SCC No. KMM-SCC-M0702 Page 1 of 2	S C C SPECIFICATION CHANGE CONTROL	PRODUCT CODE ALL 530, 830 AND 1107
---	---------------------------------------	--

ISSUE NEW PART NUMBERS FOR COIL-IGNITION

ALL 530, 830 AND 1107 ENGINES

COIL-IGNITION

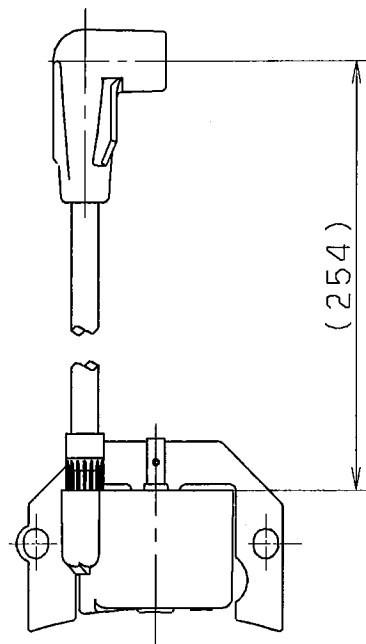
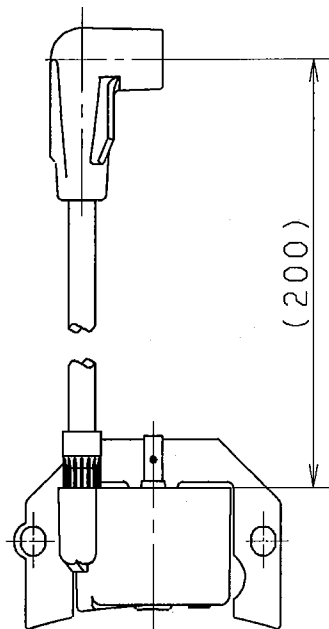
PART NUMBER	
	OLD	NEW
COIL-IGNITION	21171-7013	21171-7034
COIL-IGNITION	21171-7014	21171-7035

CHANGE SUPPLIER OF COIL-IGNITION FOR QUALITY IMPROVEMENT.
 ADD 5mm TO COIL WIRE TO IMPROVE ASSEMBLY.

21171-7013 AND 21171-7014

21171-7034 AND 21171-7035
